MILITARY SPECIFICATION

CLEANING COMPOUND WITH CONDITIONER AND INHIBITOR
FOR ENGINE COOLING SYSTEMS

This amendment forms a part of Military Specification MIL-C-10597E dated 24 August 1984, and is approved for use by all Departments and Agencies of the DoD

Figure 2

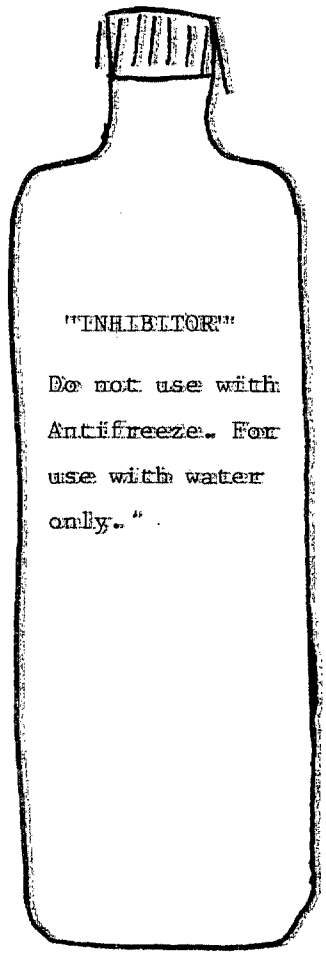
Step 3 - Inhibiting Process. Delete paragraph and replace with the following:

Inhibitor. Change drawing from a bag to a 1 qt bottle, change label to read:

"Fill the cooling system to the proper level with water and add the inhibitor from the bottle marked "Inhibitor" at the rate of 3% by volume of the total cooling system capacity (1/2 qt for a 17 qt system). If antifreeze is used, no inhibitor is to be added to the solution.

"Inhibitor"
Do not use with
antifreeze. For
use with water only.
